Request	-	Special Use Permit for School
Location	-	3547 Quast Lane
Applicant	-	Kadee Anstadt, Superintendent Washington Local Schools 3505 W. Lincolnshire Blvd. Toledo, OH 43606
Owner	-	Washington Local Schools 3505 W. Lincolnshire Blvd. Toledo, OH 43606
Architect	-	Rusty Wilke The Collaborative One SeaGate, Park Level 118 Toledo, OH 43604

SPECIAL USE PERMIT  
TOLEDO CITY PLAN COMMISSION  
REF: SUP-11003-23  
DATE: March 14, 2024  
TIME: 2:00 P.M.

# SITE PLAN SUBMITTAL FOR SPECIAL USE PERMIT

**PROPOSED SITE PLAN**  
SCALE: 1" = 50'

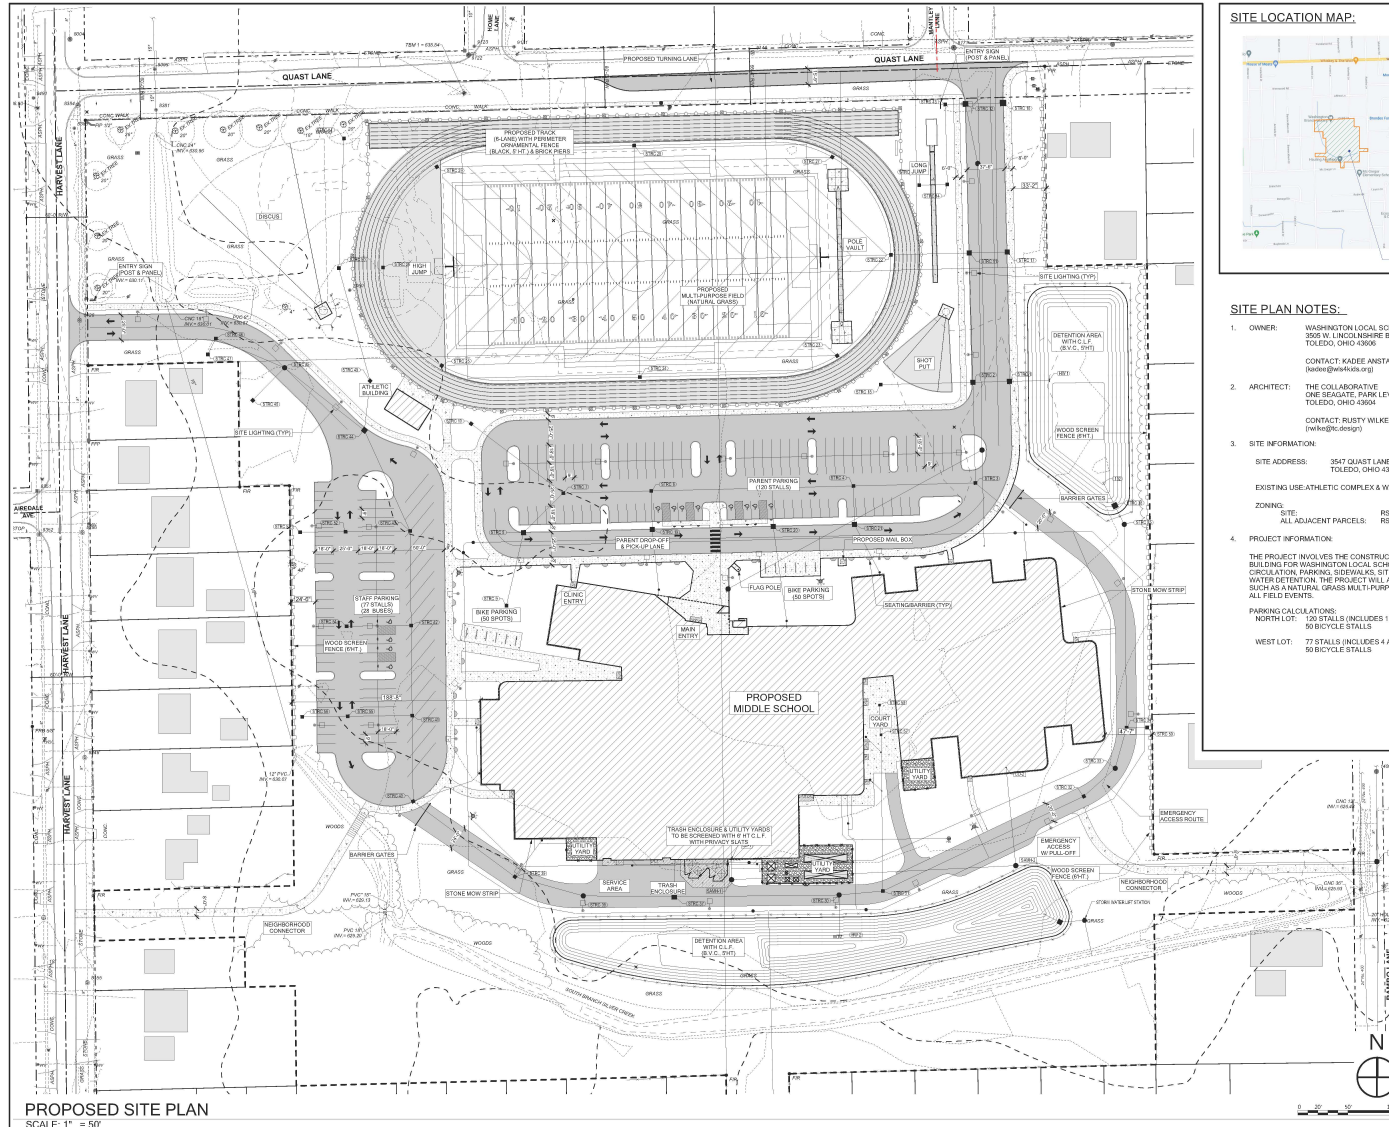
The layout of the school's parking plan is comprised of two lots: the north lot, which has access off of Quast Lane, and the west lot, which has access off of Harvest Lane. There will be one hundred and ninety-six (196) total spaces on site, in addition to sixteen bus spaces (16) in the west lot. Per TMC§1107.0304 – *Schedule "A"*, middle schools require one (1) space per faculty member, plus one (1) space per three (3) staff members, plus one (1) space per fifty (50) students for pickup and drop off. The school has an expected enrollment of 1,580 students, with one hundred sixty-five (165) faculty and twenty (20) staff, requiring two hundred and four (204) spaces. The proposed one hundred and ninety-six (196) spaces do not meet the minimum requirement per the middle school parking standards, however, the Planning Director has determined this number of parking spots is acceptable and will meet parking demands.

A portion of the total number of required off-street parking spaces must be specifically designated, located, and reserved for use by persons with physical disabilities. According to the table in TMC§1107.1701 – *Number of Required Parking Spaces for Persons with Disabilities*, the applicant is required to provide at least one (1) van accessible space with an eight-foot (8') drive aisle and six (6) car accessible spaces with five-foot (5') drive aisles for persons with physical disabilities. The off-street parking includes twelve (12) van accessible spaces and complies with the accessible parking requirements.

(TMC§1107.0300). A minimum of one (1) bicycle space shall be provided per three (3) students, plus one (1) space per ten (10) parking spaces for faculty and staff, but as per TMC§1107.0900, no more than 50 bicycle parking slots shall be required for any listed use category. The site plan depicts two areas for bicycle racks adjacent to each parking lot, both with capacity for fifty (50) bicycles, for a total of one hundred (100) bicycle parking slots. This number of slots is acceptable as depicted.

Per TMC§1108.0202 – *Frontage Greenbelts*, sites over five (5) acres are required to provide a thirty-foot (30') frontage greenbelt and contain at least one (1) tree for every thirty feet (30') of frontage. This standard applies to the 245 feet of frontage along Harvest Lane on the northwest corner of the site, as well as the 960 feet of frontage along Quast Lane. The two frontages total to 1,205 feet and require forty-two (42) trees. The submitted site plan depicts eight (8) new trees and nine (9) existing trees, which are credited per TMC§1108.0407(1)(B) and count as fifty-six (56) trees due to their caliper. The frontage greenbelt meets requirements in terms of number of trees, however, a portion of the greenbelt along Quast Lane is only twenty-five feet (25') wide. The applicant shall obtain a waiver for this section of the frontage greenbelt.

The entry drive off of Quast Lane depicts four (4) trees that are forty feet (40') apart and no continuous shrub hedge. However, there is a fence depicted between this entry drive and the abutting residential lots that will provide adequate screening. The entry drive off of Harvest Lane depicts five (5) trees that are sixty feet (60') apart and no continuous shrub hedge. The number of trees along this driveway are acceptable due to their anticipated size, however, revised plans shall show a continuous shrub hedge to provide adequate screening between this entry drive and the abutting residential lots.

The maximum building height in the RS6-Single Family Residential zoning district for schools, per TMC§1106.0206, is sixty (60) feet. Elevations submitted to the Plan Commission indicate the height of the tallest portion of the building is sixty-seven (67) feet and two (2) inches. Staff is supportive of a waiver to allow this height, as the building is setback an appropriate distance from the abutting residential parcels.

Approve waiver for the frontage greenbelt requirement. The site plan depicts a twenty-five-foot (25') frontage greenbelt along a portion of Quast Lane and is acceptable as depicted. Most of the frontage greenbelt meets the thirty-foot (30') requirement.

Approve waiver for the perimeter landscape requirement along western side of the west parking lot, where three (3) trees are missing. The proposed fencing will provide adequate screening between abutting residential lots.

Approve waiver for perimeter landscaping along entry drive off of Quast Lane and entry drive off of Harvest Lane. The trees along both drives are further than thirty feet (30') apart there are no proposed shrubs in the landscape plan. The depicted trees are adequate due to expected size. The missing shrubs along the Quast entry drive are acceptable, as there is a proposed fence that will provide adequate screening between abutting residential lots. The applicant will provide the shrubs missing along the Harvest Lane entry drive, as there is no proposed fence along this drive.

OVERALL  
LANDSCAPE  
PLAN

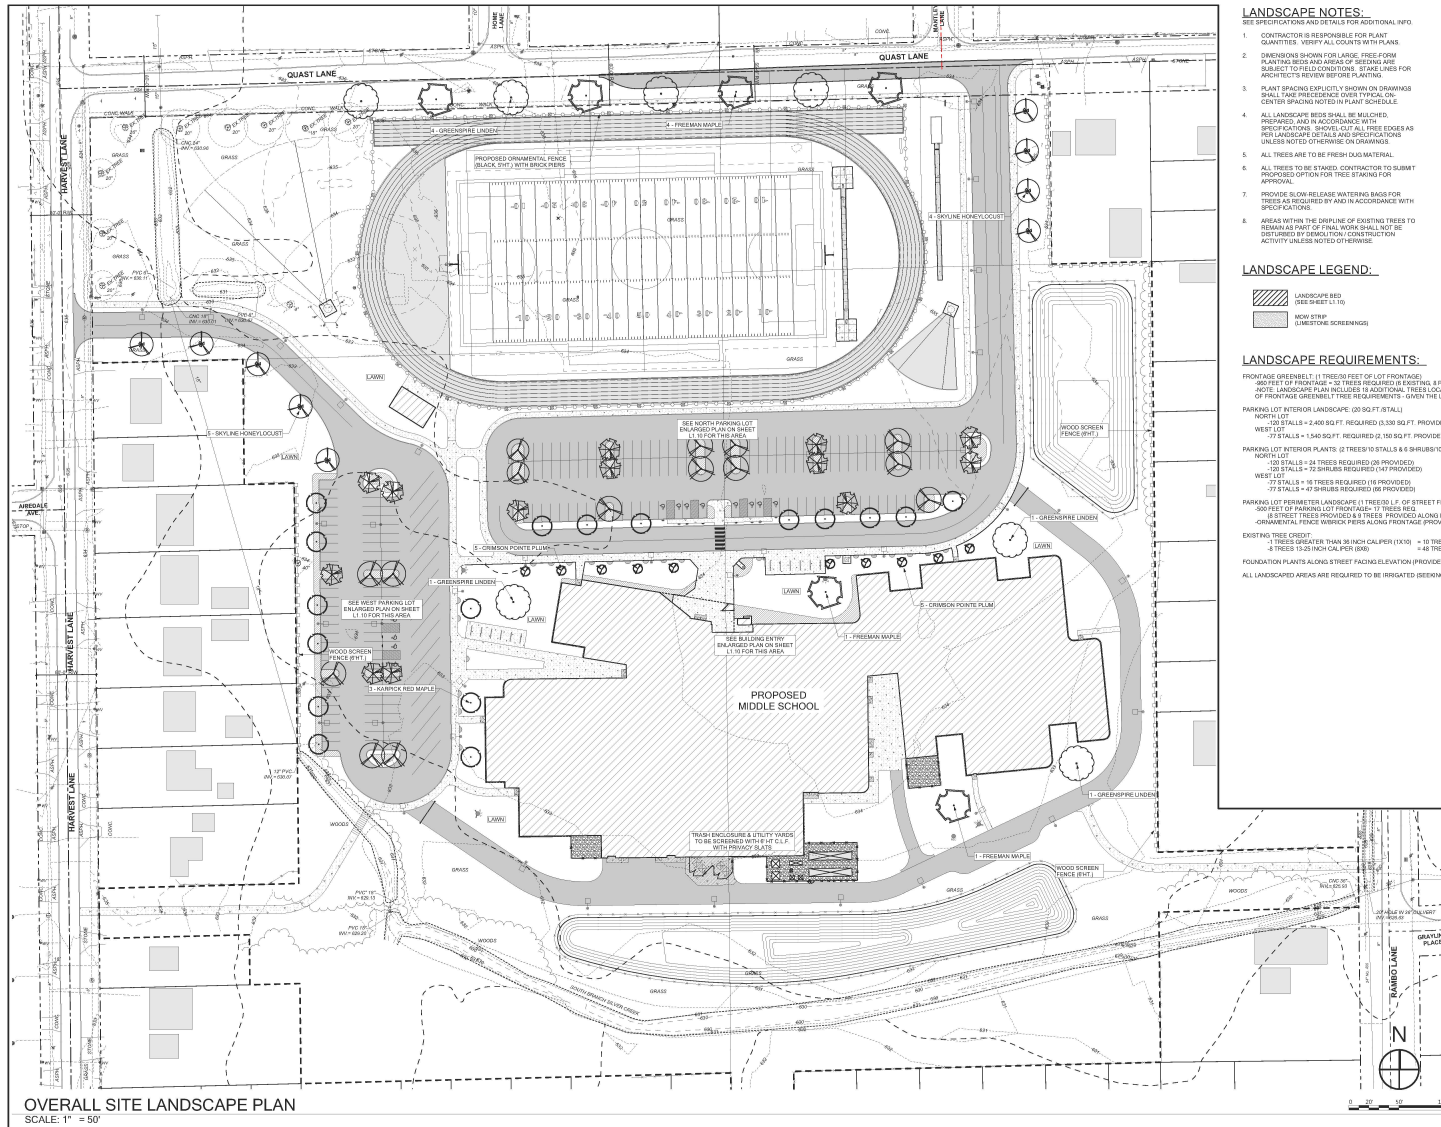
Parking lot landscaping is essential in preventing headlights from being seen from public rights-of-way, curbing the urban heat island effect, and in beautifying the site. TMC§1108.0204 – *Parking Lot Landscaping (Interior and Perimeter)* states a perimeter landscape buffer shall be provided abutting the parking area to visually screen all off-street loading facilities from view of Residential districts and public right-of-ways. A minimum of at least one (1) canopy tree must be provided for each thirty (30) linear feet, plus a continuous shrub with a minimum height of eighteen inches (18"). The site plan depicts six (6) trees and a continuous shrub hedge along the western side of the west parking, which is two hundred and seventy (270) feet long. This length of parking lot is missing three (3) trees, however, a six-foot (6') wooden screen fence is also depicted along the lot, which provides adequate screening between the abutting residential lots.

Pursuant to TMC§1108.0204(B), the total interior landscaping required for parking lots is twenty (20) square feet per parking space. The site's parking lots contain a total of one hundred and ninety-six (196) parking spaces, which requires a minimum of 3,920 square feet for interior

landscaping provided within the parking lots. Additionally, two (2) canopy trees and six (6) shrubs are required to be installed in interior landscape areas for each ten (10) parking spaces within the parking lot. One (1) canopy tree may substitute for three (3) shrubs. A total of forty (40) trees and one hundred and nineteen (119) shrubs are required in the interior parking. The site plan shows 5,480 square feet of interior parking lot landscaping, comprised of forty-two (42) trees and two hundred and thirteen (213) shrubs. These plantings meet this requirement.

Approve a waiver to not require irrigation for the site. The funding source for construction of the new school does not cover costs for an irrigation system. Additionally, the project is seeking to be LEED certified, and irrigation is not permitted in order to obtain certification. The landscaping schedule shows native plantings with high tolerance to drought.

# ELEVATIONS

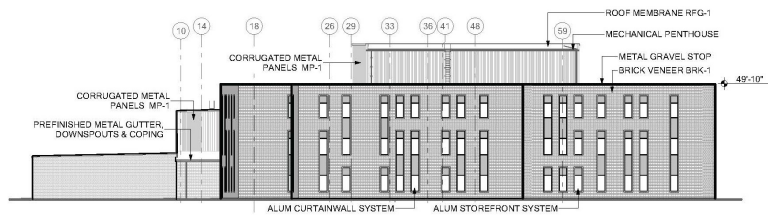
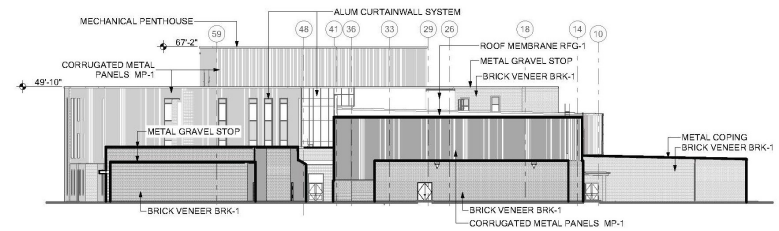
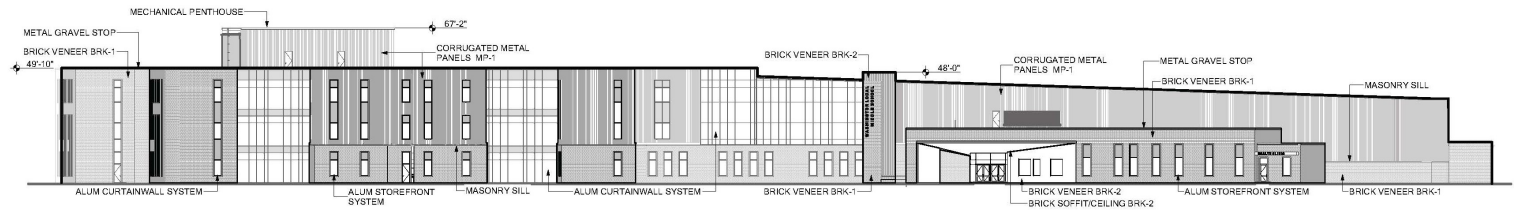
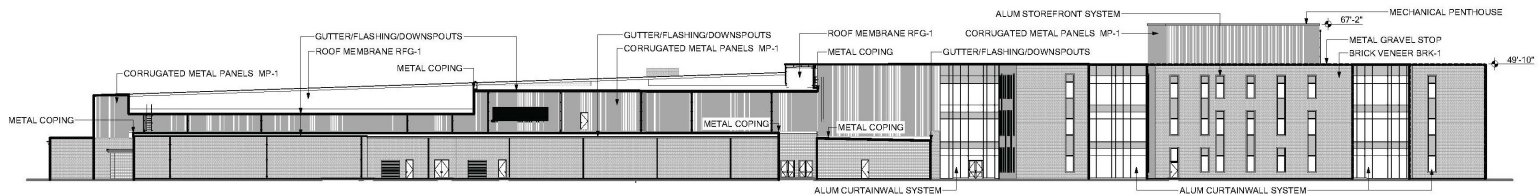
Furthermore, the submitted building elevations depict a combination of brick masonry (48%), architectural metal (33%), and glass and glazing (19%). These are the same materials that were previously approved and installed at Shoreland Elementary and Silver Creek Elementary. As all of these materials are listed as approved predominant materials in TMC§1109.0500 – *Building Façade Materials and Colors*, the elevation plans are acceptable as depicted.

Approve waiver for additional seven feet and two inches (7'2") over the maximum height requirement as the proposed school is set back far enough from the abutting residential parcels.
